MEQI-50&63 Profile Modification & LC Accessory Adjustment

MEQI-50/63

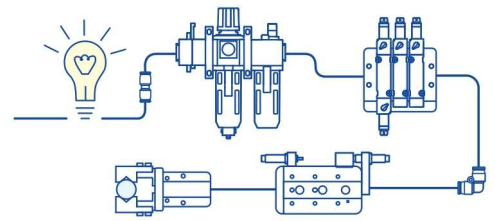
The contour dimensions of the front and rear parts have been slightly increased. Even without LC accessories, they can be directly installed onto the customer's equipment without interfering with the cylinder tube. The external design of the LC accessories has also been adjusted simultaneously to ensure that original customer dimensions remain unaffected.

- a. Dimensional details are provided in the attachment.
- b. The new MEQI-50/63 profile requires the new LC accessories and is incompatible with legacy LC accessories.
